The Executive Director, Resource Assessments  
Department of Planning and Environment  
GPO Box 39 Sydney NSW 2001

My name is Dr Hugh Barrett and I wish to **OBJECT** to the proposed Narrabri Gas Project (NGP).

### **Methane doesn't contribute to global warming???**

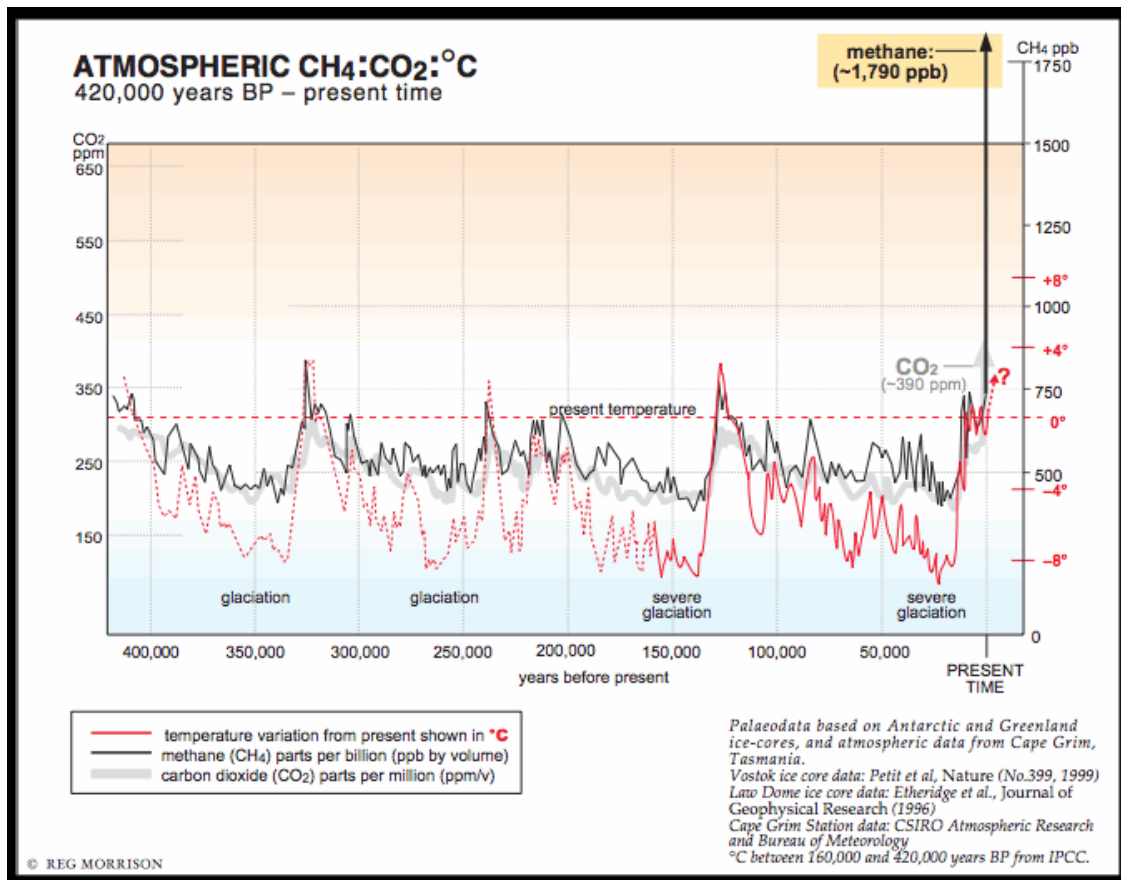
The concentration of methane in Earth's atmosphere is rising exponentially, as shown in the following graph. The release of further methane to the atmosphere will have catastrophic consequences for global warming and climate change.
